HISTORIC PRESERVATION BOARD

HISTORIC PRESERVATION BOARD MEETING

The Historic Preservation Board will hold a remote meeting on Wednesday, April 20, 2022, 5:00 PM. This meeting will take place remotely using Zoom pursuant to the Remote Meeting Policy adopted by the Historic Preservation Board and as authorized under 1 M.R.S. 403-B because of the existence of an emergency or urgent issue that requires the committee to meet by remote methods.

STATUS:

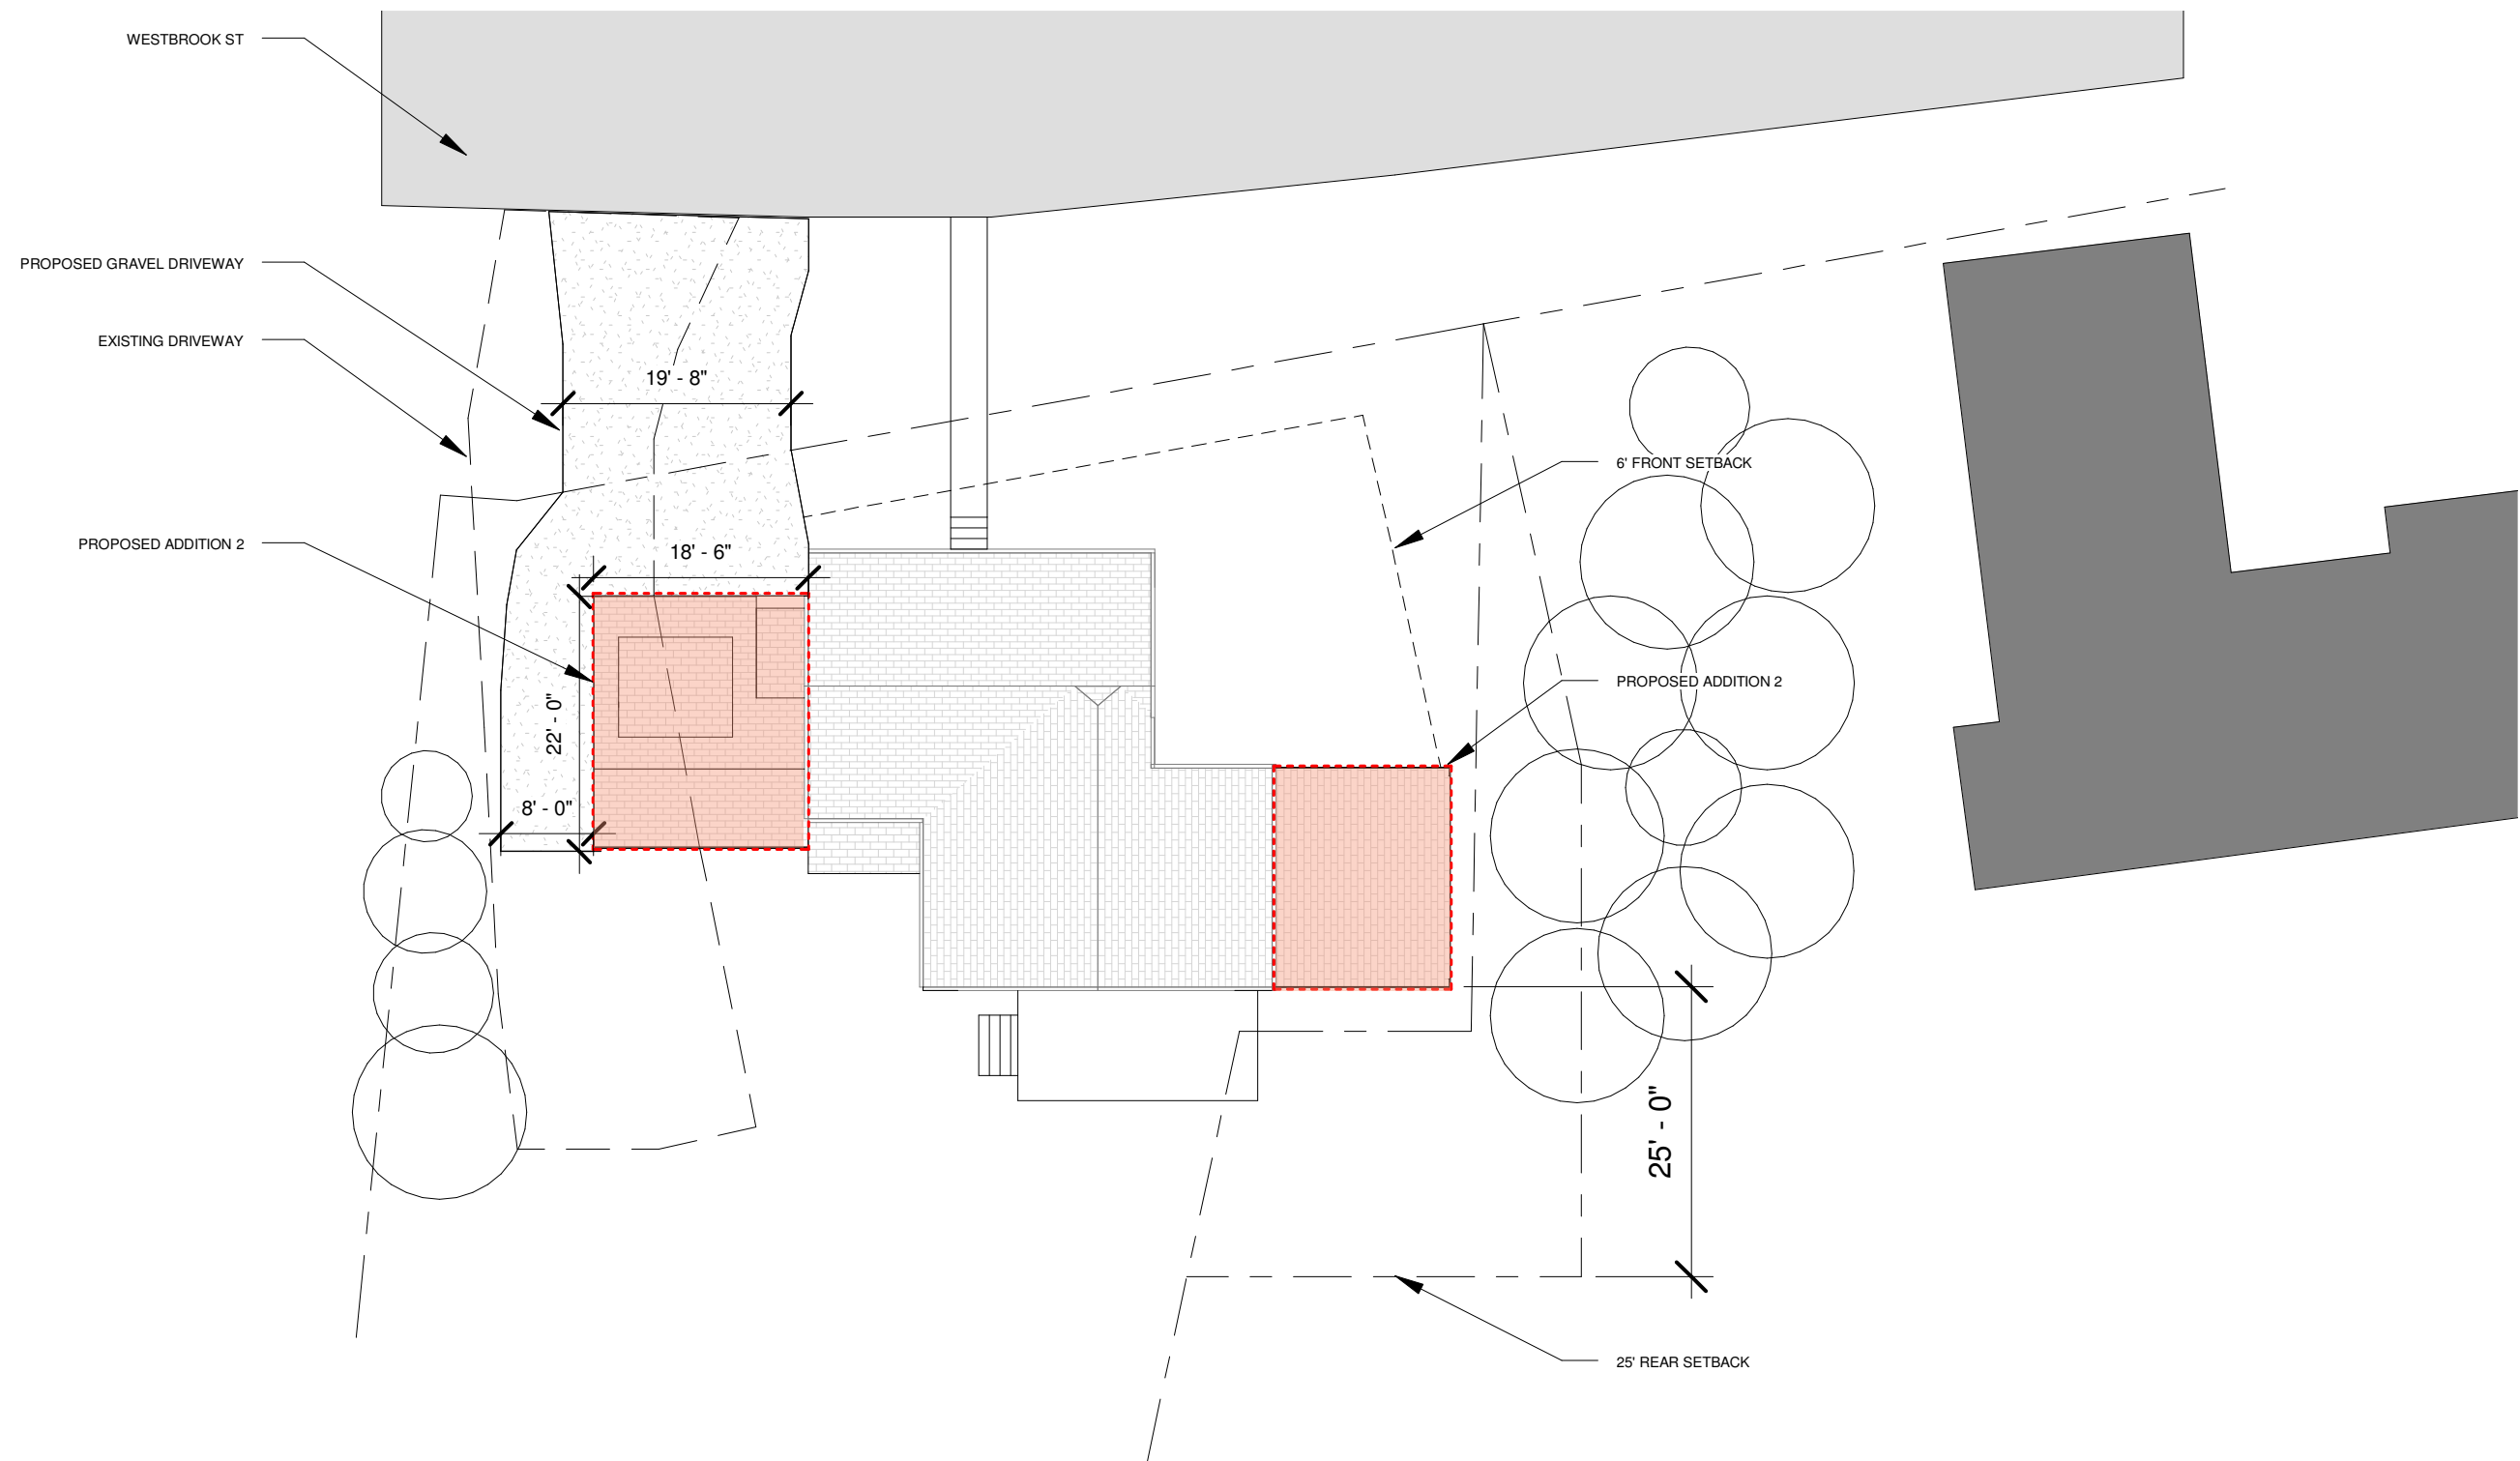
Site Alterations: Staff suggests that Board members ask for clarification about the scope and nature of site alterations, as the enclosed site plan and renderings are not consistent. For example, is a stone wall and second walkway from the driveway to the front door proposed? Will there be a transition in paving materials for the area on the southeast side of the garage, as suggested?

The roof over the connecting entryway between the new garage and the existing house has been held back from the front edge of the garage/MBR addition by 12", and the front door has been set back 42" from the roof edge to more clearly articulate the space between the old and the new. The revised configuration reduces the visual impact of the garage/MBR addition on the original house. Allowing the garage/MBR addition to read as more separate from the historic house, more legible as an addition and not part of the original structure. The breezeway has a full glass door and sidelight on the front, creating a clear separation between the historic house and the garage/MBR addition. The garage door has been moved to the inside of the entryway, to simplify the exterior form of the garage at this important intersection.
